**Subject:** Application No: DA2020/0816 Address: Lot 38 Sec F DP 7236 and Lot 2 DP 748426 33 Bassett Street Mona Vale.

**DEVELOPMENT APPLICATION DA 2020/0816  
23-33 BASSETT STREET MONA VALE  
PROPOSED RESIDENTIAL CARE FACILITY UNDER SEPP HOUSING  
FOR SENIORS**

**Figure 1-** North elevation showing west boundary of site and relationship with adjoining cottage style development

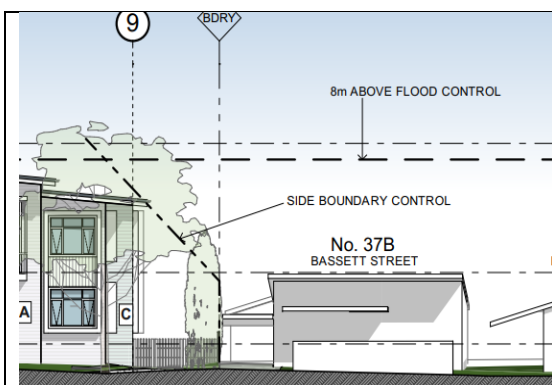
This site is not in a medium density residential zone nor is the property located in a mixed use commercial type environment. The fact that the site is zoned for 'low density residential' purposes should be instructive to the applicant as far as the development proposal is concerned. This is especially the case where low density residential extant development is to be replaced by a high density facility (over the eastern part of the land). We contend that the architect has failed to take into account the reasonable expectations of adjoining land owners and occupiers in this regard. Figures 1 and 2 below show the relationship between the proposal and adjoining development to the east and west (source Gartner Trovato Architects). In our opinion the separation between the built elements in Figure 1 is not acceptable.

**Figure 2-** North elevation showing east boundary of site and relationship with adjoining cottage style development

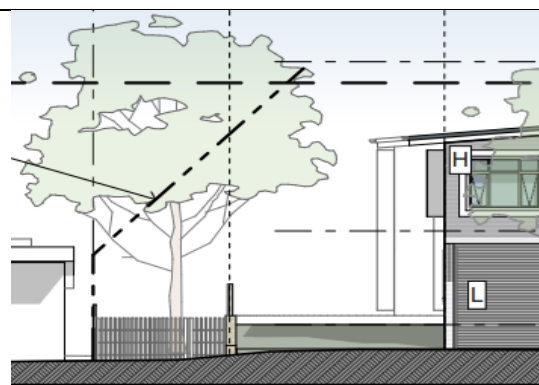
We note that the proposed floor space ratio (FSR), which is set at 0.95:1 means that in this case, given the restricted height, a very squat disproportionately lengthy built form of around 95m will result. Further however, the building is excessively bulky and is not satisfactorily relieved and articulated when viewed from the street frontage and both the east and western boundaries. From the south, the significant setback means that the bulk and scale will be a far less critical issue, in terms of the public domain or amenity.

In our view the building should be broken into at least two built elements crossways, so that some respect can be paid to the built form of existing cottages in other parts of this streetscape (with their narrow frontages), the relevant low density zone and the PDCP character statement suggesting that vegetation should be integrated with development. In this case the reduced street setbacks will not allow for sufficient planting to soften this bulky and very lengthy facade.
